Work Order ID 69639

Item Name: Crosstube Turning Detail

DART AEROSPACE LTD	Work Order: 69639
Description: Crosstube Assembly (205/212/412 High Fwd)	Part Number: D212-664-141
Inspection Dwg: D212-664-141 Rev: D	Page 1 of 1

DRAWING NO. D212-664-141	TITLE XTUBE ASSY (205/212/412 HI FWD)	REV. D	DART AEROSPACE LTD ENGINEERING ORDER		D.E.O. NO. D212-664-141-D-1	SHEET NO. SHEET 1 OF 2	SCALE NTS
DRAWN	CHECKED	MFG. APPR.	APPROVED	DE APPR.			
DATE 11.04.07	DATE 11.04.11	DATE 11.04.12	DATE 11/04/12	DATE 11.04.12

**D212-664-141/-141B
ASSEMBLY DETAIL**

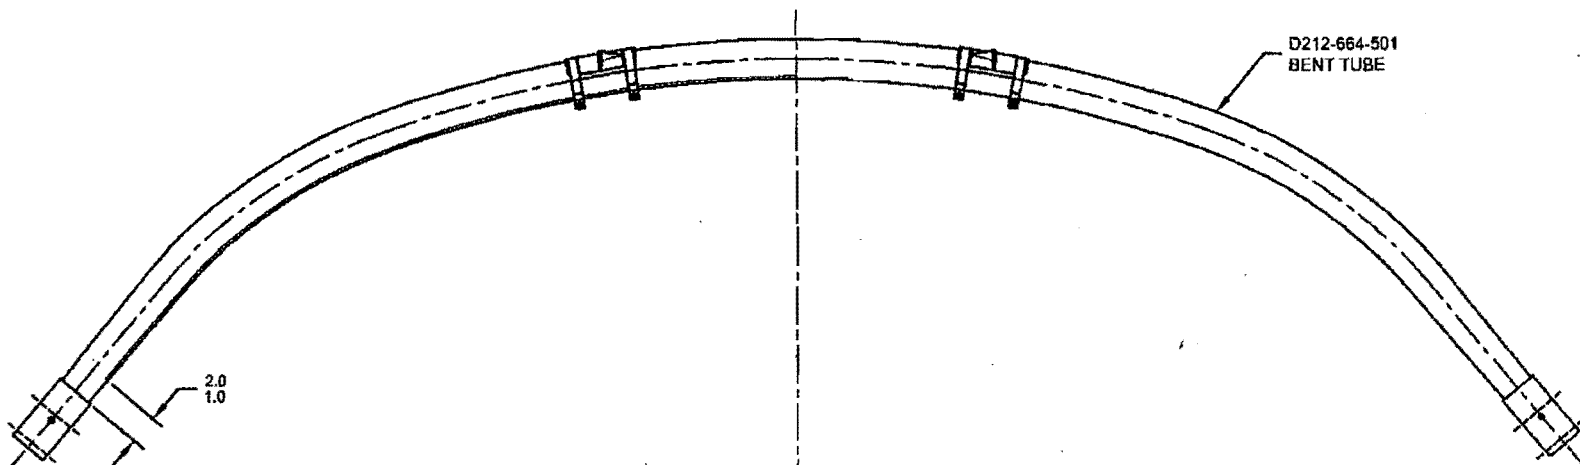
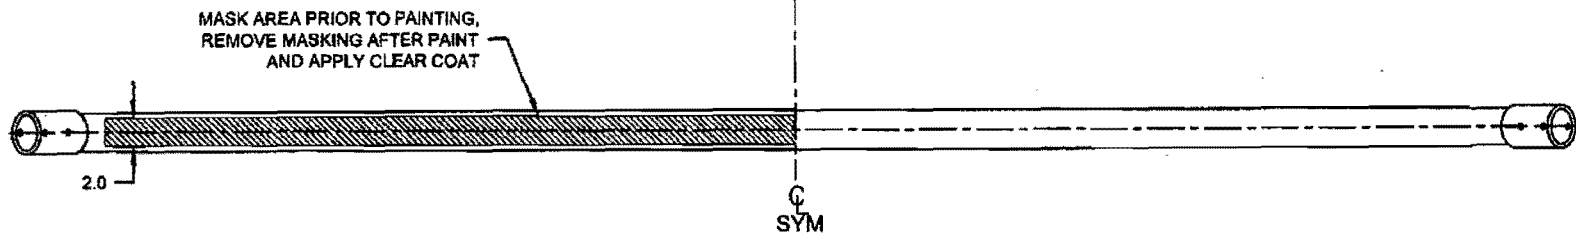
ADD AN INSPECTION WINDOW TO UNDERSIDE OF CROSSTUBE.

NOTES 2 OF SHEET 1 IS AMENDED AS FOLLOWS:

- 2) FINISH: CHEMICAL CONVERSION COAT PER DART QSI 005 4.1
PRIME INSIDE AND OUTSIDE PER DART QSI 005 4.2
MASK UNDERSIDE OF CROSSTUBE AS SHOWN (HATCHED AREA) AND
PAINT OUTSIDE PER DART QSI 005 4.2
REMOVE MASKING AND APPLY CLEAR COAT

- 2) FINISH: CHEMICAL CONVERSION COAT PER DART QSI 005 4.1
PRIME INSIDE AND OUTSIDE PER DART QSI 005 4.2
PAINT OUTSIDE PER DART QSI 005 4.2
